**Capital School District
Central Middle School
Interior Renovations
211 Delaware Ave. Dover Delaware 19901
Bid Pac E– Contracts 1 thru 10
October 7, 2024**

Addendum No. 1

ADDENDUM 1

PROJECT: Central Middle to Elementary School Interior Renovation

1 FIRST FLOOR PLAN - AREA D/E
NORTH

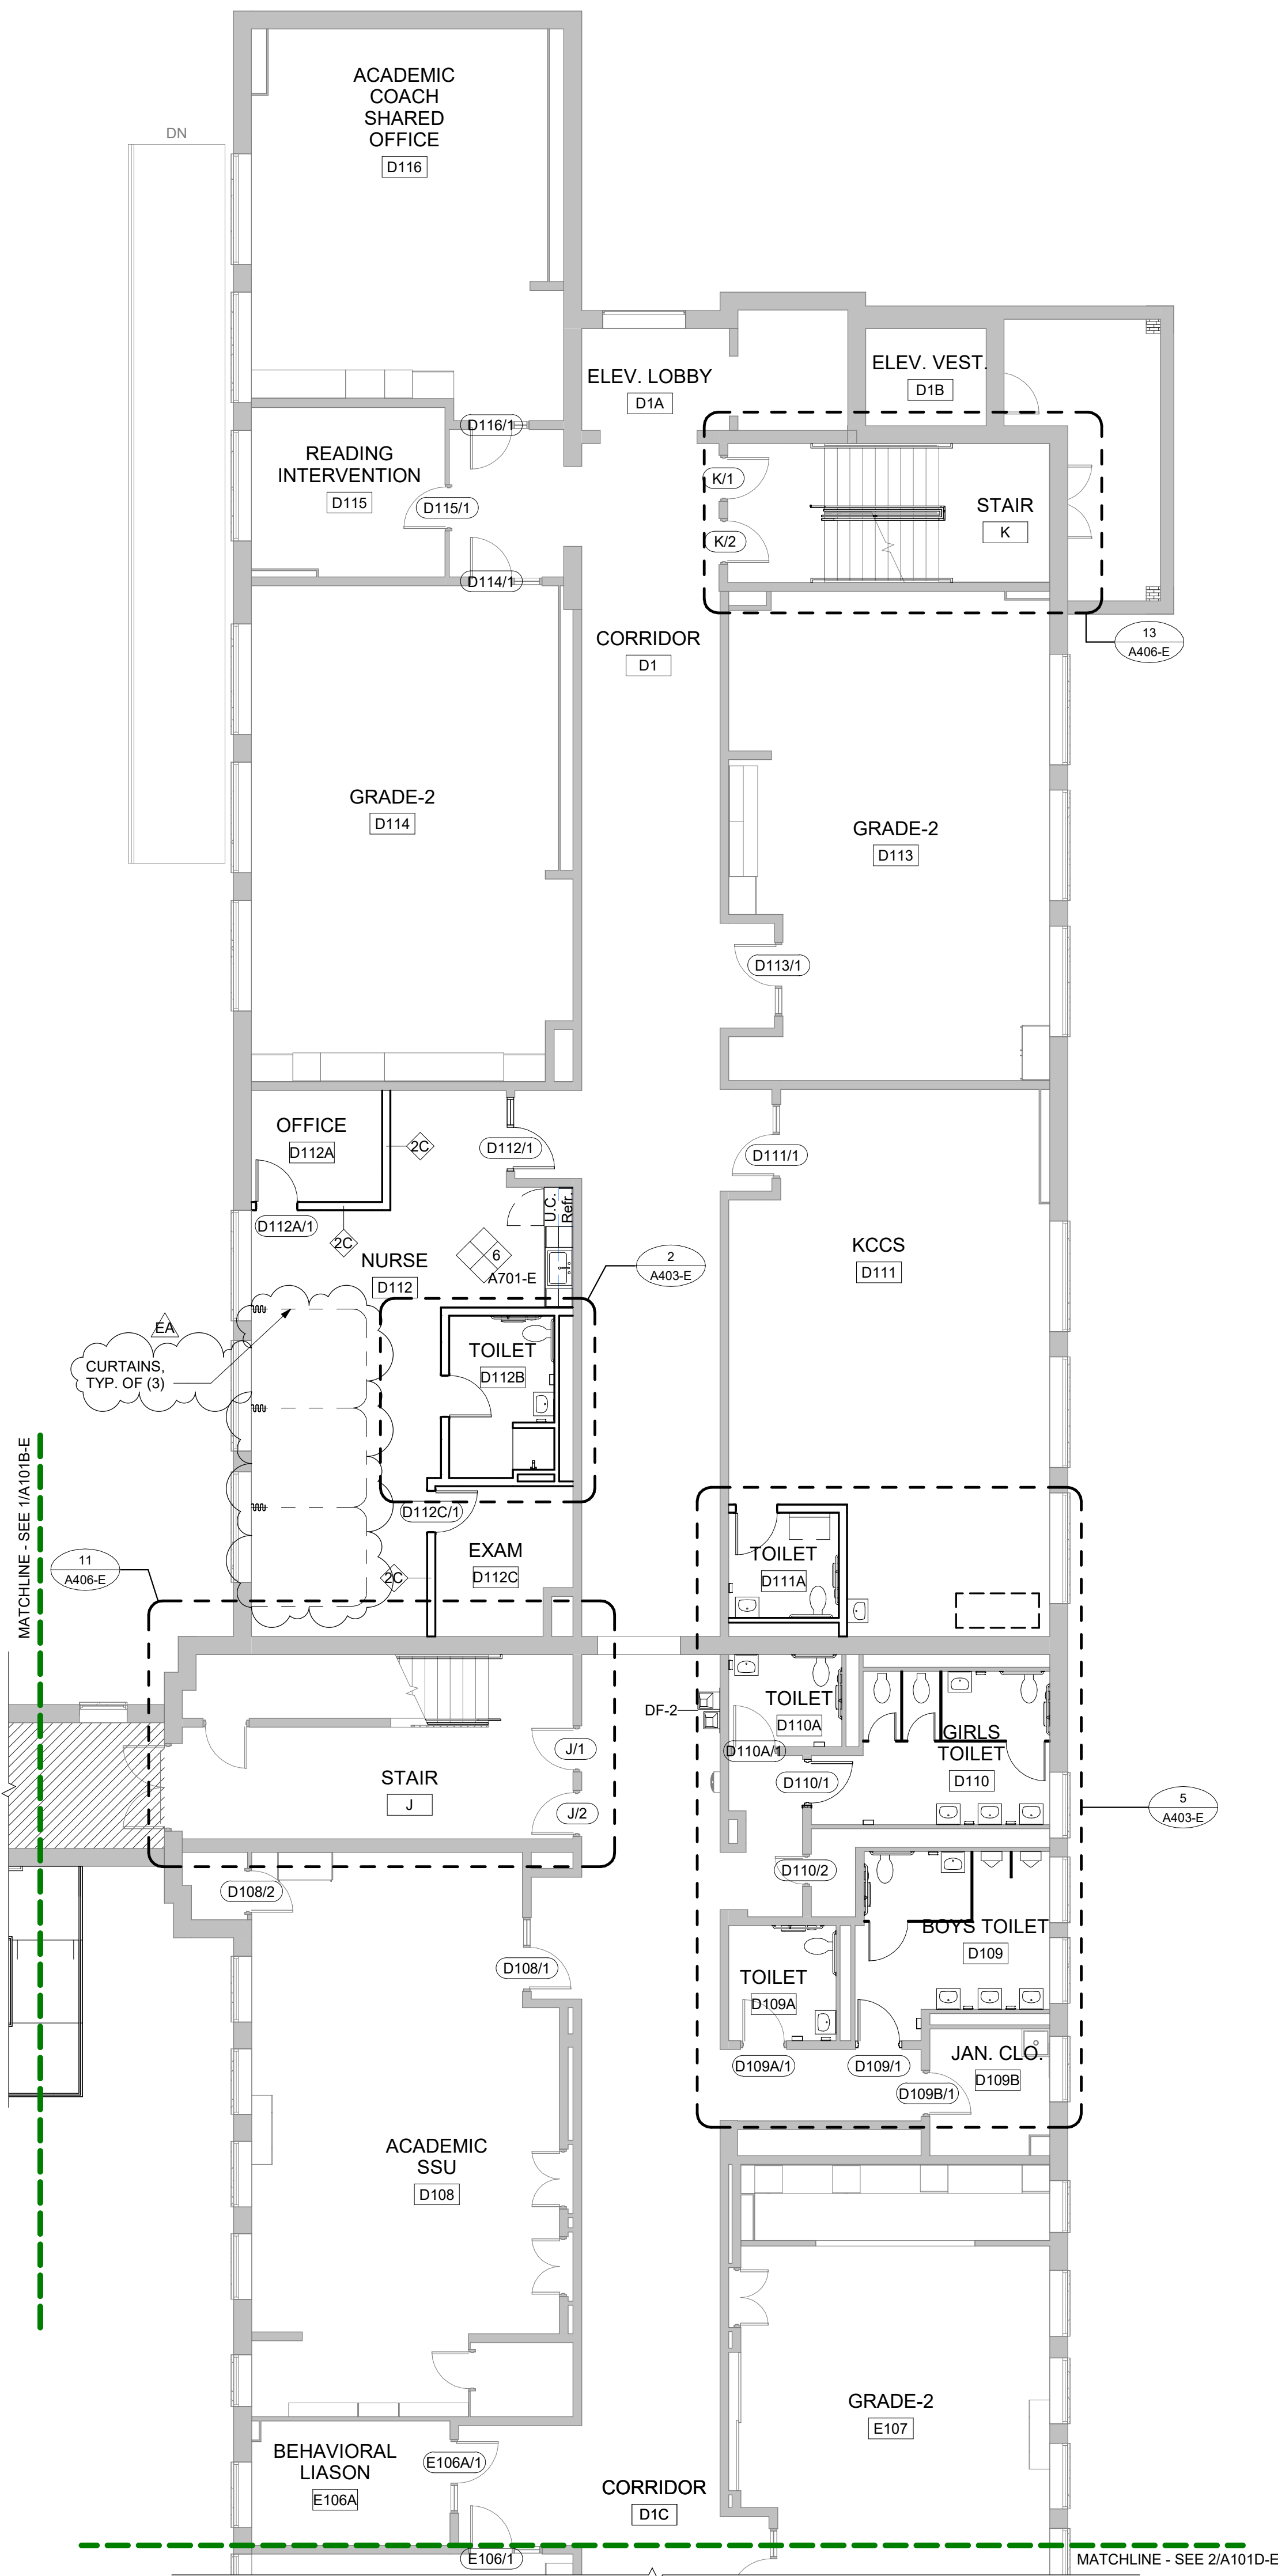
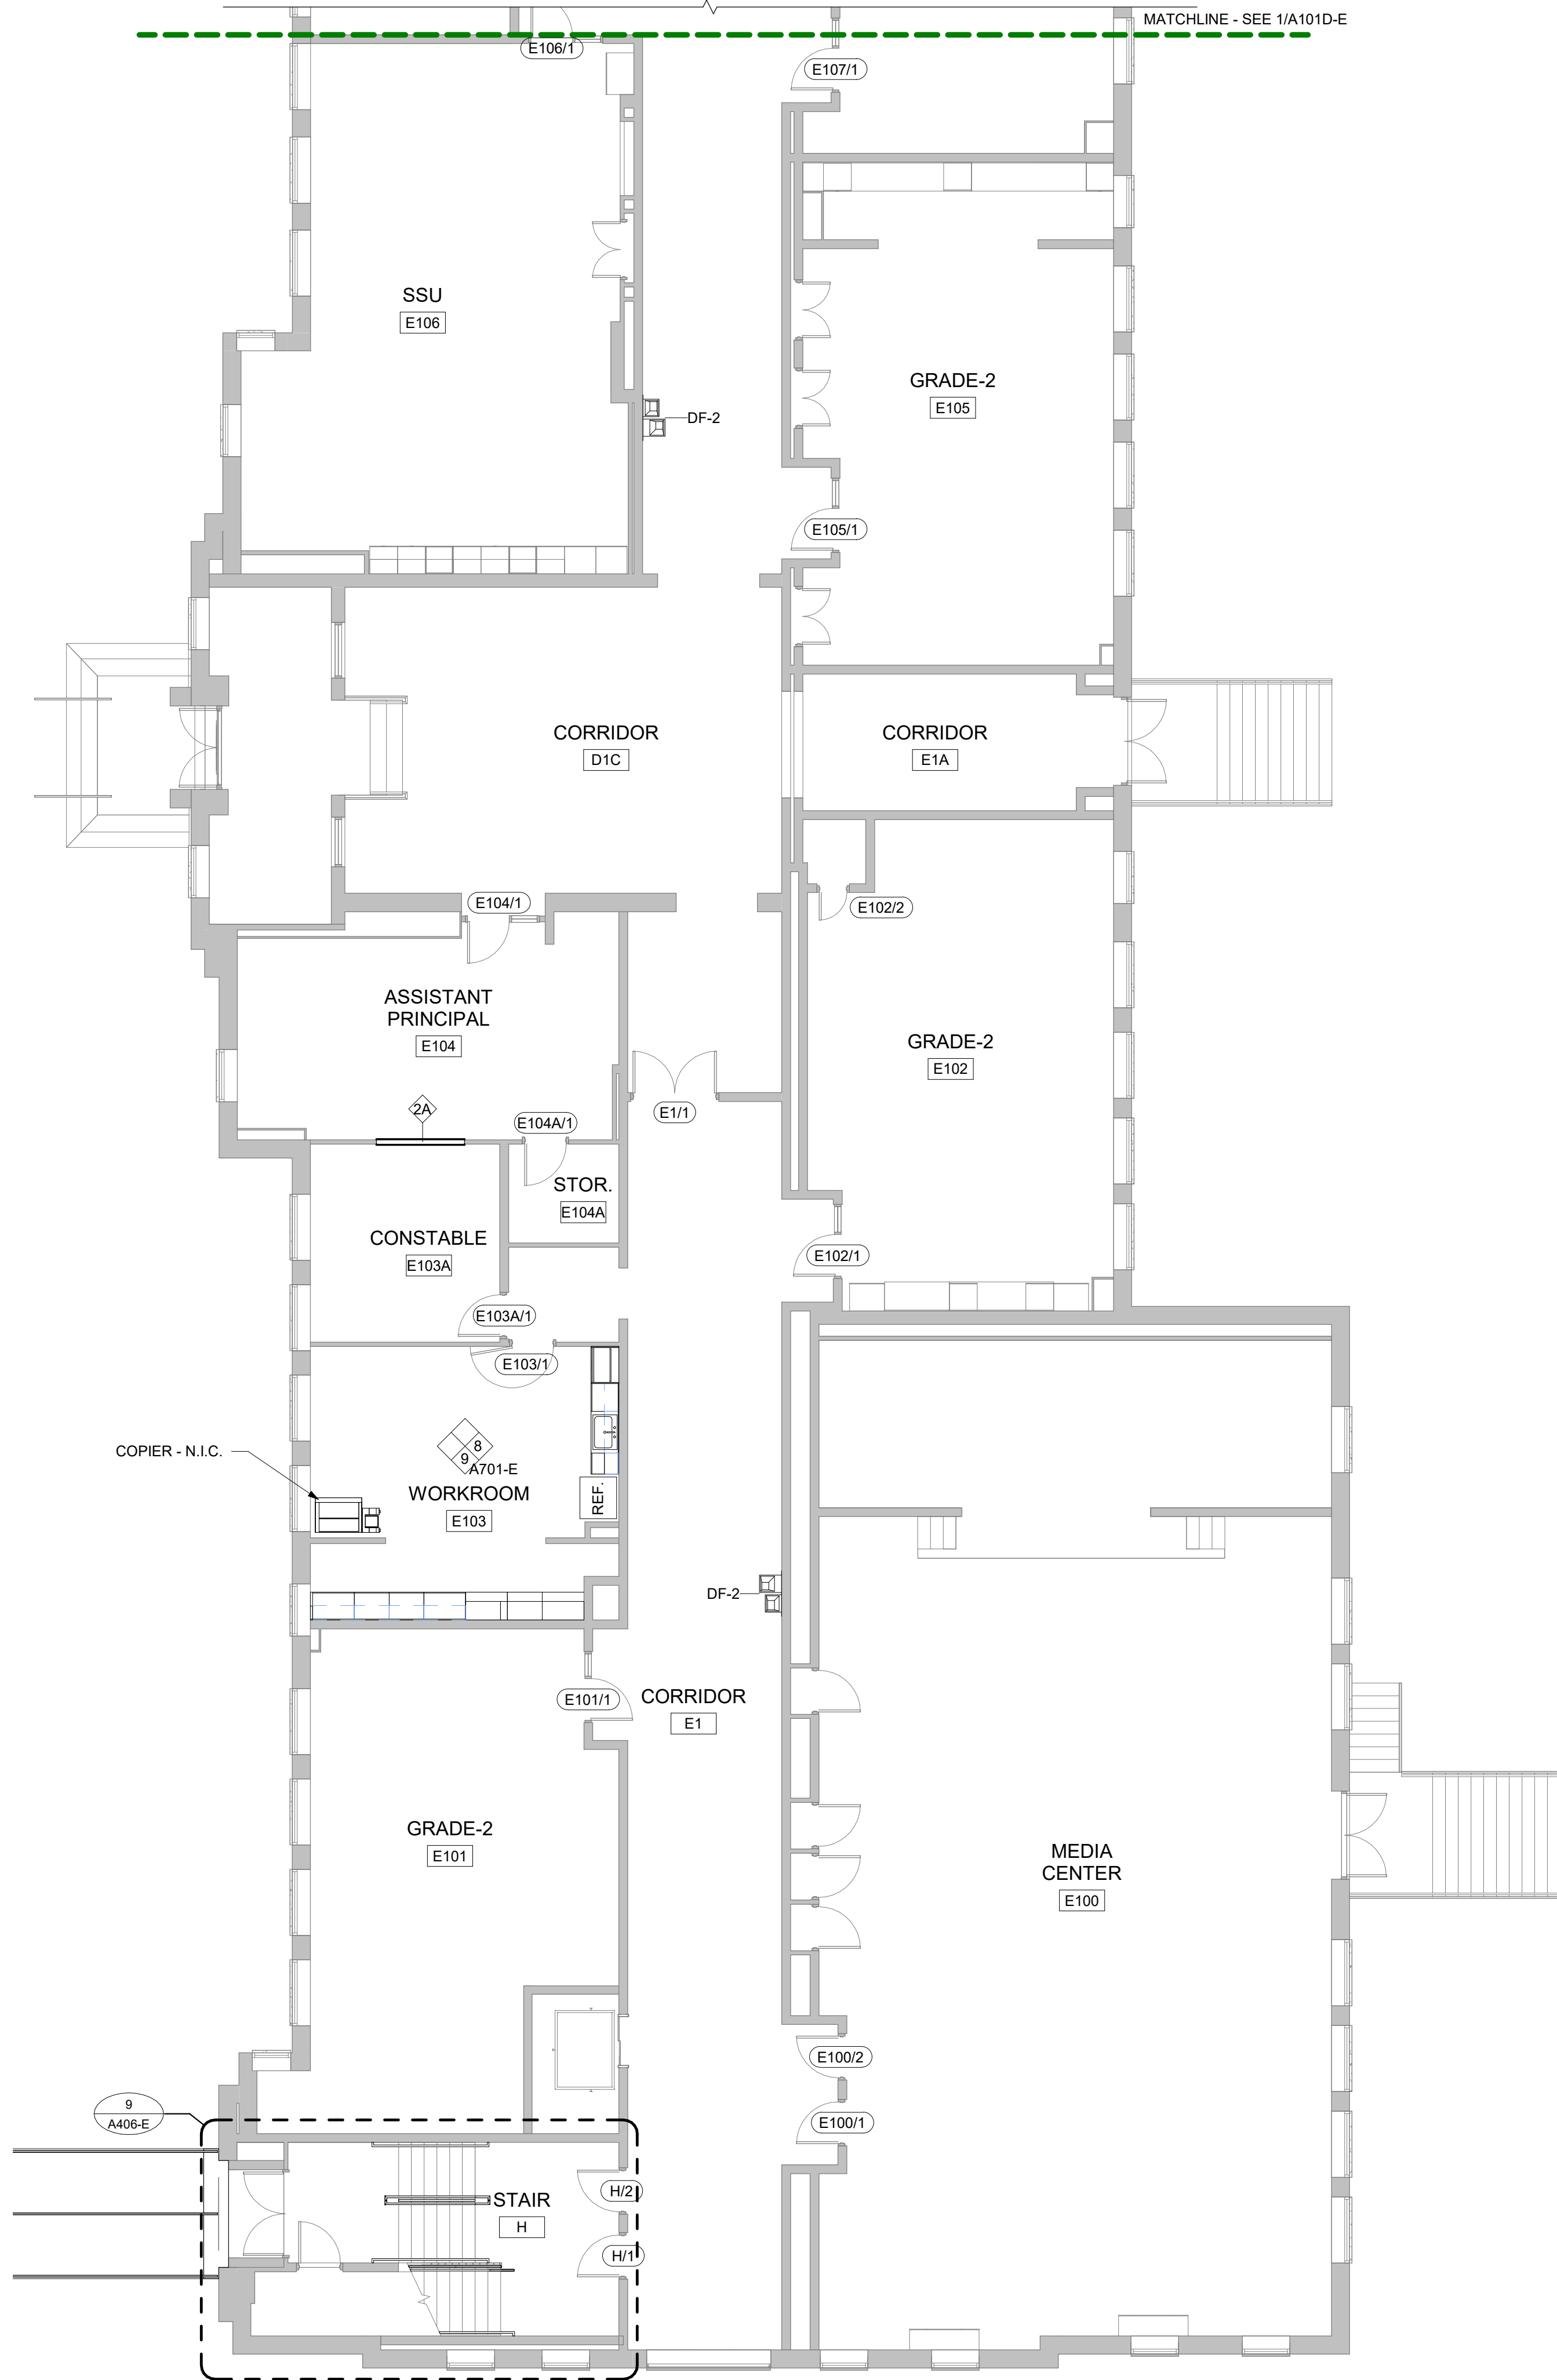
2. A101D-E – FIRST FLOOR PLAN – AREA D/E

- a. Detail 1:
 - i. **ADD** exam curtains (3) in nurse's suite.

S8 FINISH TRANSITION - RUBBER SHEET FLOORING TO EXISTING VCT

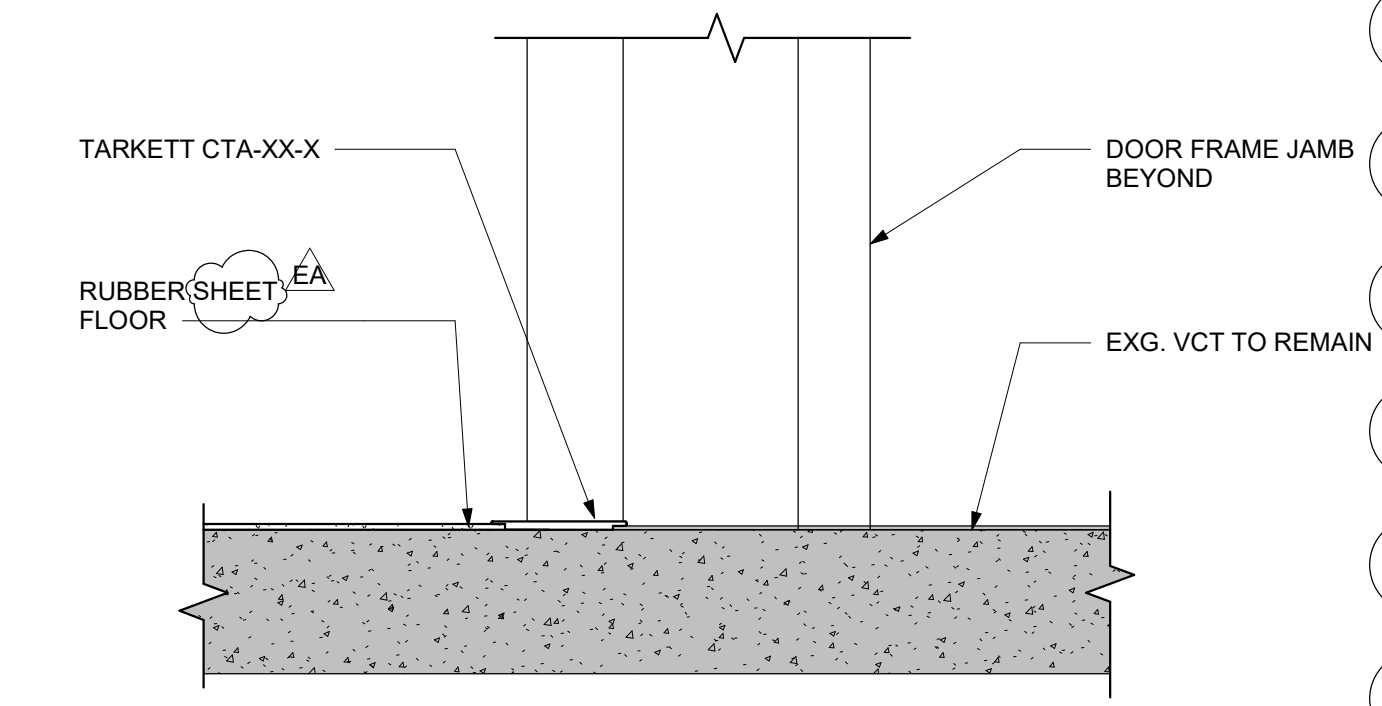
4. A602-E - INTERIOR FLOORING TRANSITION DETAILS

- a. **DELETE** details S6 and S9.
- b. Details S8 and S14:
 - i. **REVISE** drawing title and drawing note from "Athletic" to "Sheet".
